**Gerald R. Ford International Airport**

**Taxilane L Construction**

**PROJECT NUMBER C-416**

**ADDENDUM #2**

**CONSTRUCTION**  
**SAFETY AND**  
**PHASING PLAN -**  
**WORK AREA A**

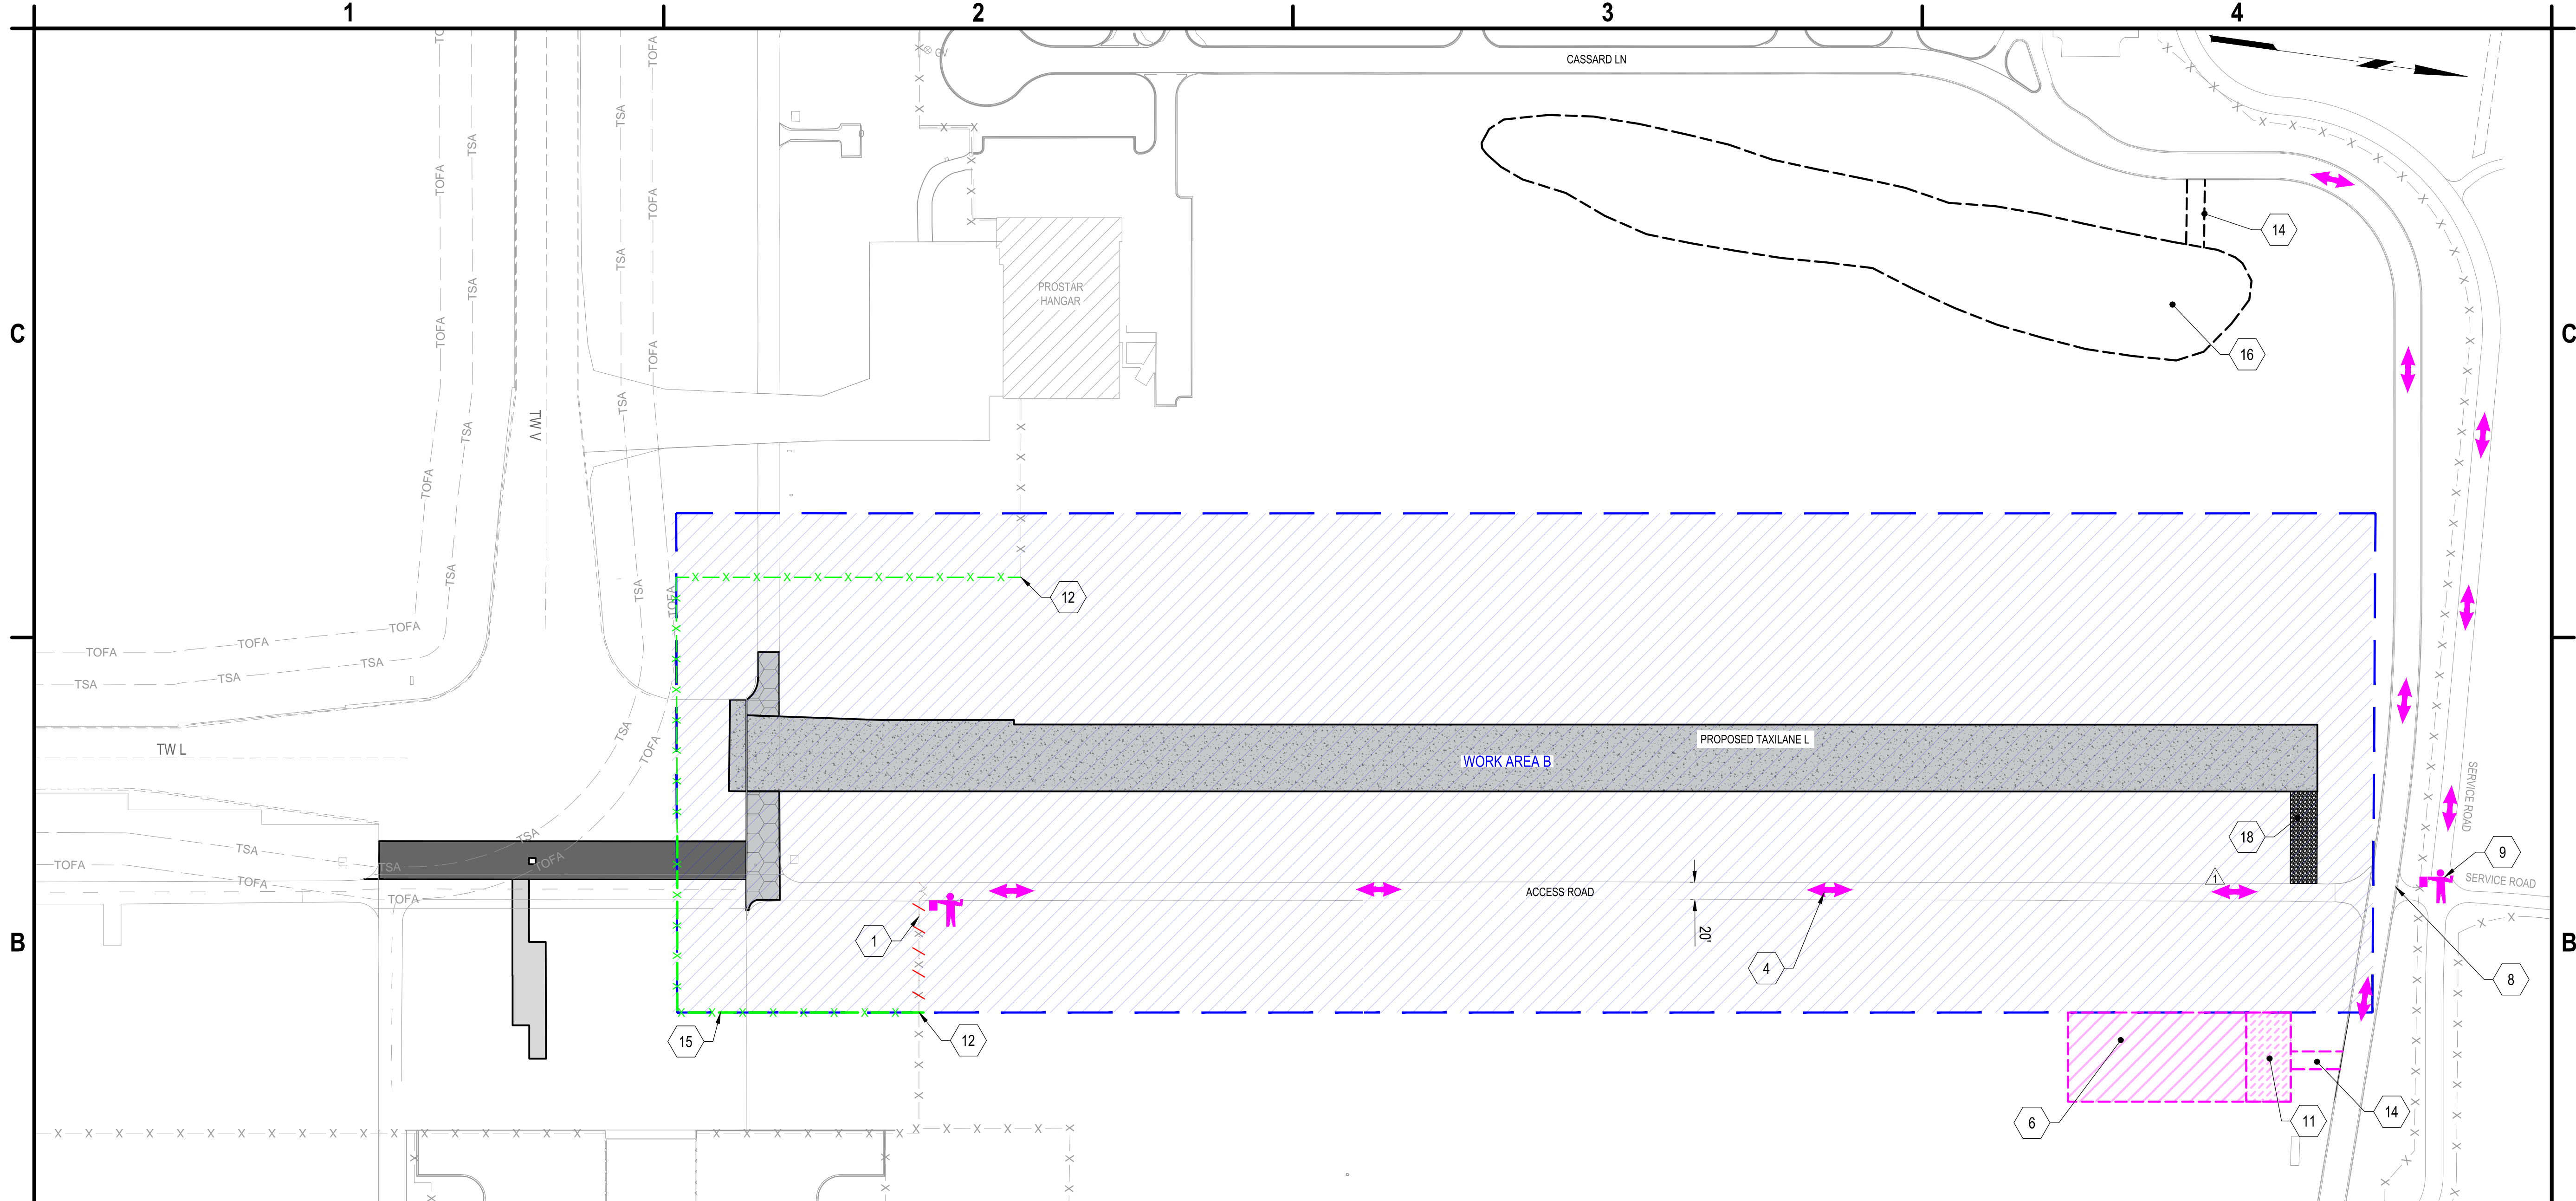
- Q: GC101 & GC102 have contradicting information on Work Area A & B and the durations. A3 says both durations for both areas. Is the smaller area inside the airfield Area A? Is it the 30 CD time limit?

- Q: At the meeting, it was mentioned that the airport would supply and install the interlocking low profile barricades. GC101 would seem to indicate that it is the Contractor's responsibility. Please clarify.

- A: Work area A shall be limited to 30 days and Work Area B shall be limited to 82 days. GC101 and GC102 have been updated accordingly see the drawings section of this addendum.

- A: The airport will provide the barricades for the project. It will be the responsibility of the contractor to install and maintain them throughout the duration of the project. Keyed note 3 on sheet GC101 has been updated for clarity, see the drawings section of this addendum.

1. REMOVE EXISTING AOA FENCE, ITEM F-162
2. INSTALL TEMPORARY FENCE ON CONCRETE BARRIER, ITEM CX-106, SEE DETAIL B1/GC501
3. INTERLOCKING AIRFIELD BARRIERS TO BE PROVIDED BY THE AIRPORT. IT WILL BE THE RESPONSIBILITY OF THE CONTRACTOR TO INSTALL AND MAINTAIN THEM THROUGHOUT THE DURATION OF THE PROJECT PER DETAIL A1/GC501
4. CONTRACTOR HAUL ROUTE
6. CONTRACTORS STAGING AREA
9. CONTRACTOR PROVIDED GATE GUARD AT GATE 79 (ONLY REQUIRED DURING CONSTRUCTION ON WORK AREA A)
12. TRANSITION EXISTING FENCE TO TEMPORARY FENCE ON CONCRETE BARRIER, ITEM CX-106, SEE DETAIL B1/GC501.
13. CONTRACTOR'S ACCESS TO WORK AREA A, GATE 72
16. BORROW AREA
17. LIMIT OF FENCE REMOVAL DURING WORK IN AREA A

1. WORK AREA A SHALL OCCUR CONCURRENTLY WITH WORK AREA B AND SHALL OCCUR WITHIN THE TOFA OF TAXIWAYS V AND L AND WILL RESULT IN TEMPORARY CLOSURES OF THE TAXIWAY PAVEMENTS. WORK SHALL CONSIST OF MARKING, ELECTRICAL MODIFICATION, AND ANY NECESSARY DRAINAGE, GRADING, AND PAVING ITEMS. WORK AREA A SHALL BE CONCURRENT WITH WORK AREA B AND IS LIMITED TO 30 CALENDAR DAYS.
2. WORK AREA B SHALL OCCUR OUTSIDE OF THE AOA TO MINIMIZE IMPACT ON AIRPORT OPERATIONS. WORK AREA B SHALL CONSIST OF THE EXCAVATION, GRADING, PAVING, AND MARKING OF TAXILANE L. THERE ARE NO ANTICIPATED CLOSURES TO AIRFIELD PAVEMENTS DURING CONSTRUCTION IN WORK AREA B. WORK AREA B IS LIMITED TO 82 CALENDAR DAYS.

**A2** CHAIN-LINK FENCE DETAIL

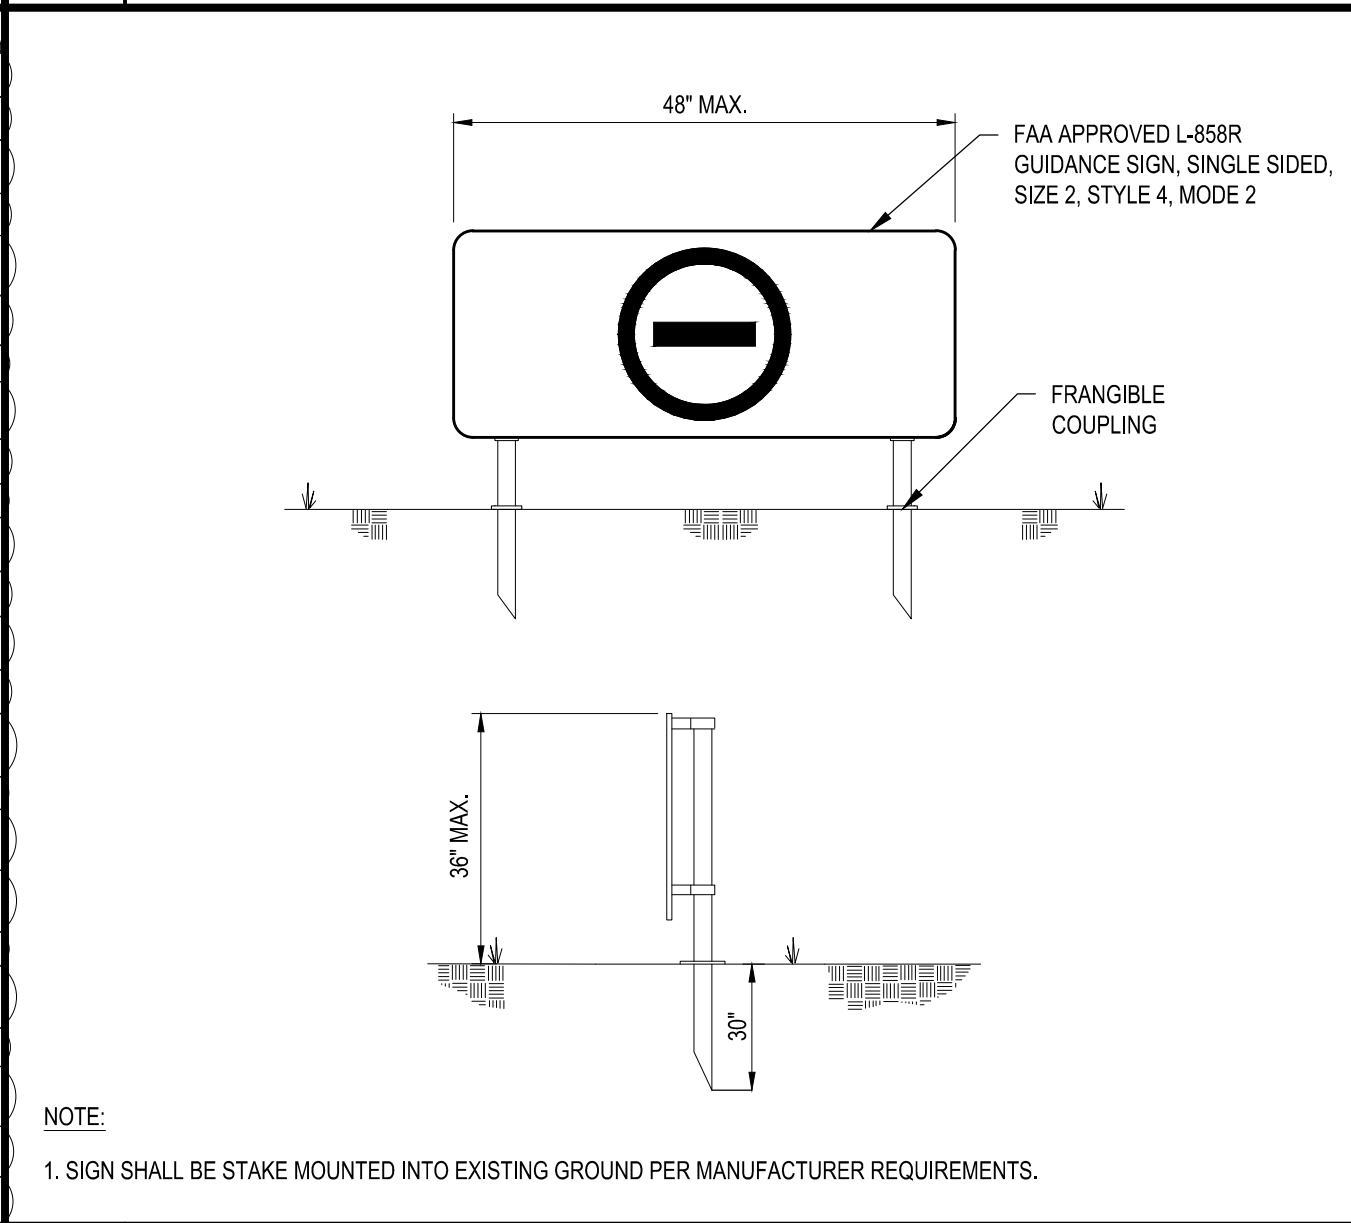
- Q: The Chain-Link Fence Detail (A2) of Drawing XM501 (Sheet #36 of 36) indicates that the fence is to have a “Continuous Top Rail”. I don’t believe any of the existing AOA fencing currently onsite has top rail. Please advise.

- A: A2/XM501 has been updated, see the drawings section of this addendum.
- Q: The Chain-Link Fence Detail (A2) of Drawing XM501 (Sheet #36 of 36) and the written specifications indicate that the Chain-Link Fence fabric and posts are to be galvanized. Some of the fence in that area and some of the fence that we are attaching to is Black Vinyl Coated. Please confirm that this project is galvanized.

- A: Proposed fence shall be galvanized.
- Q: In regard to the borrow onsite line item. Is there a grading plan or will there be grades that the borrow area will have to be placed back to?
